**CENTER FOR DRUG EVALUATION AND
RESEARCH**

208276Orig1s000

CLINICAL REVIEW(S)

Device Name P140032 - RIS – Remodulin Implantable System [SynchroMed implantable pump]

Figure 1-1: Remodulin Implantable System

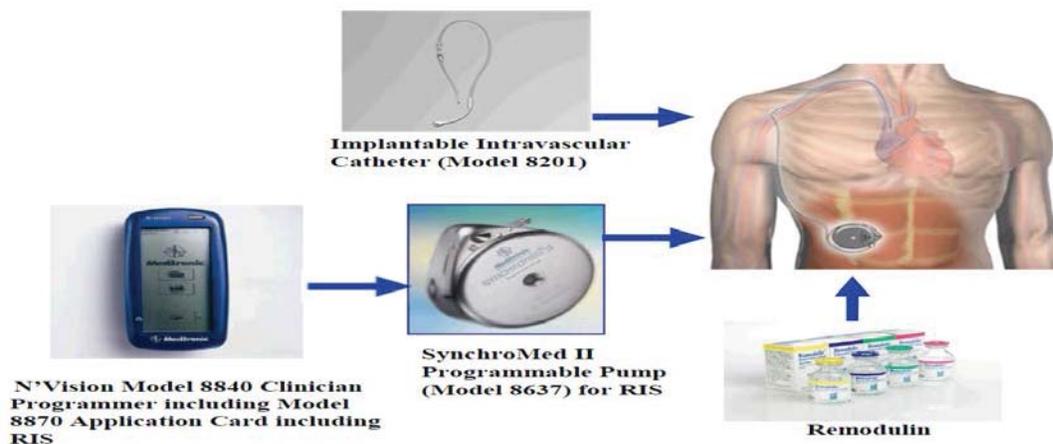
Catheter: Reviewer comments: *Of significant note, the catheter that is being proposed for marketing in the RIS system (Model 8201) is not the same one that was used in animal or clinical studies (Model 10642). Note the excerpted portion of the Table below from the submission,*

Figure 16 Time to First Post-implant System-related Adverse Event Excluding Unavoidable AEs

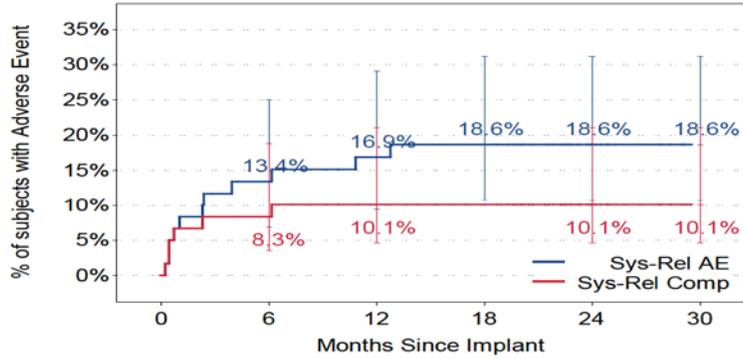
Figure 16 from the submission shows the timing of the first system-related adverse event and first system-related complication excluding the unavoidable adverse events. The estimated rate of system-related complications at 6 months post-implant is 8.3% (95% confidence interval: 3.6%-18.9%).

Figure 24 Plasma Treprostinil Levels (K2 and K3 Samples)

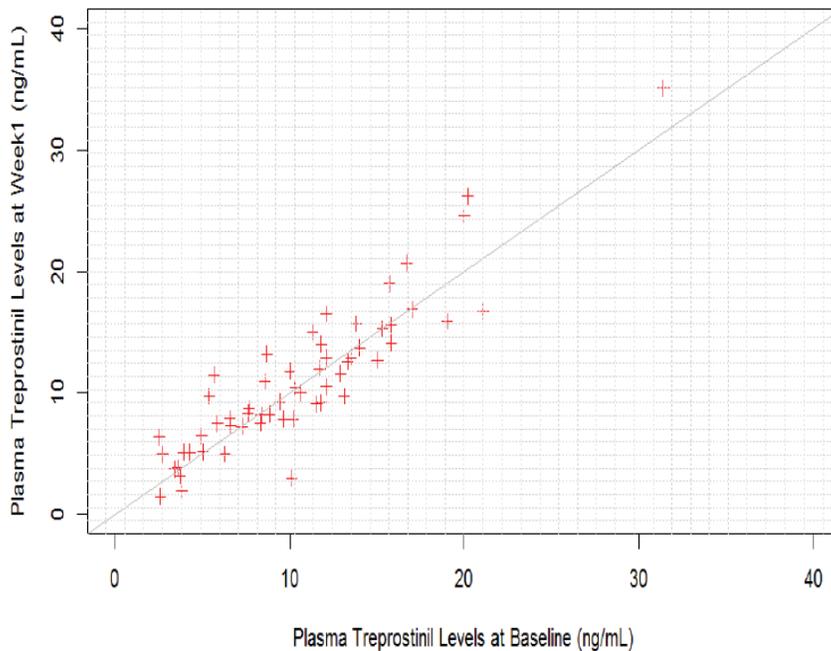
Reviewer comments: *This reviewer must defer evaluation of treprostinil levels to CDER as this reviewer does not have the background for determining if this range of fluctuation is acceptable (though Sponsor points out that this is acceptable in a chronic implant pump)*

Figure 7. Kaplan-Meier Plot of Survival

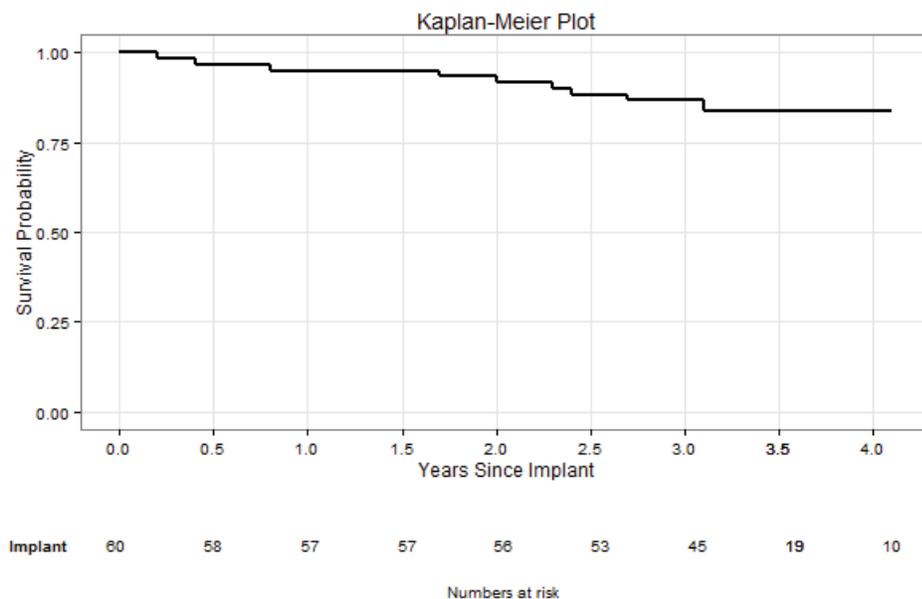
Reviewer’s comment: Mortality rates in this trial appear in the same range to the rates reported in uncontrolled long-term trials of treprostinil. Per the Tyvaso label, the Kaplan-Meier estimates of survival at 1, 2, and 3 years were 97%, 91% and 82%, respectively, in the open-label extension to the pivotal trial. Per the Orenitram label, survival was 92%, 87% and 82% at the end of 1, 2, and 3 years.

Figure 8. Expected vs. Actual Reservoir Volume

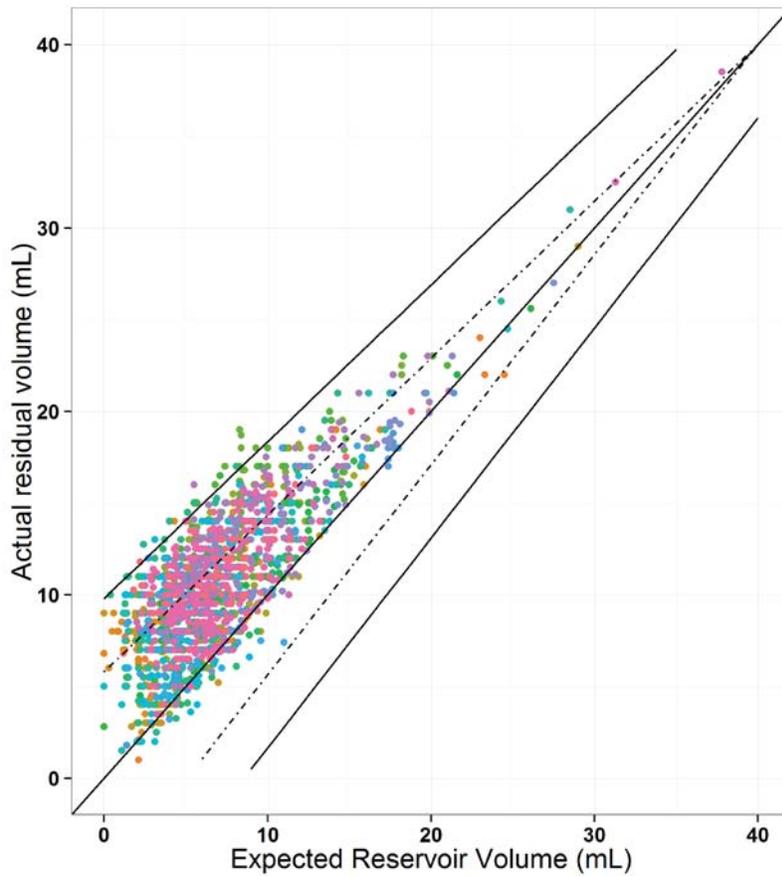
The applicant allowed a 14.5% delivery accuracy plus a 10% measurement error in the actual residual volume. There were 24 (1.3%) measurements that exceeded the pre-specified accuracy threshold as shown in figure below.

Figure 9. Line Plot of the Accuracy Ratio over Time for Individual Subjects

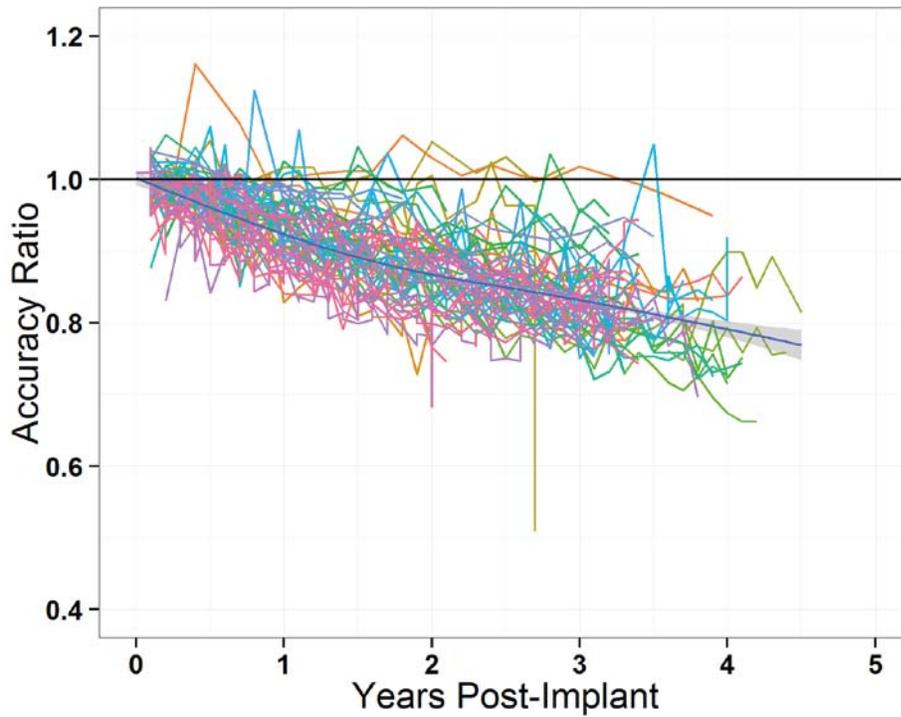
The following figure shows that the Accuracy Ratio decreases over time. The accuracy ratio was approximately 0.8 after 3 years.

Figure 10. Line Plot of the Change in Remodulin Dose over Time for Individual Subjects

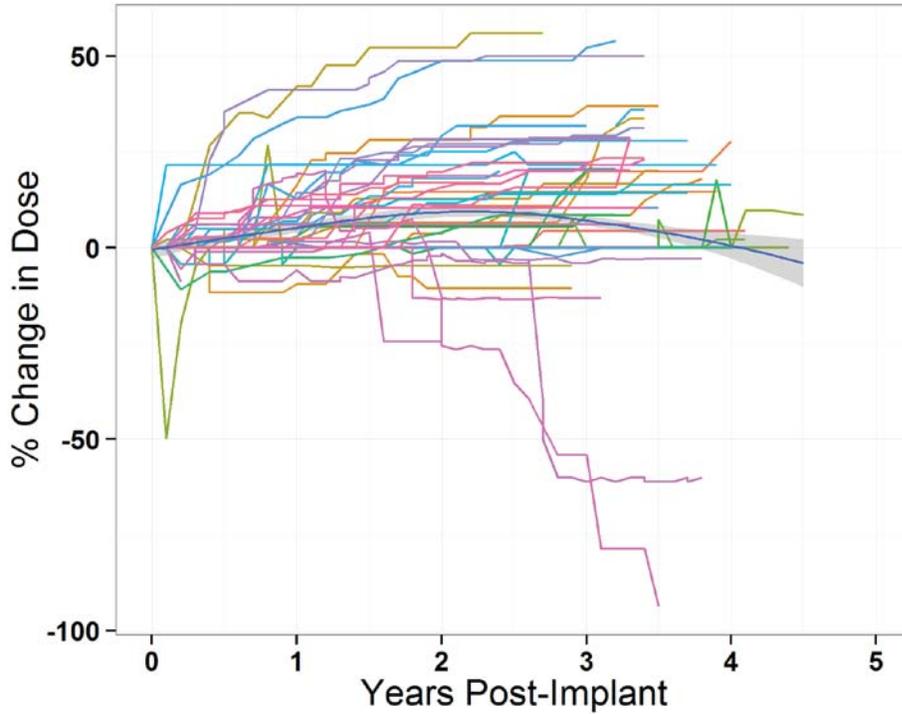
There is a trend for the Remodulin dose to increase with time as shown in the following figure. At the last clinic visit as of the data cutoff date (08 Jan 2016), 22 (36.7%) of the 60 subjects were receiving the same or a lower dose than that at Baseline. There was no correlation between change in accuracy ratio and change in Remodulin dose.

Reviewer's comment: It is not clear whether the increase in dose is related to the decrease in accuracy ratio or normal clinical management of PAH subjects. According to the Orenitram USPI, the dose of Orenitram continued to increase over time.
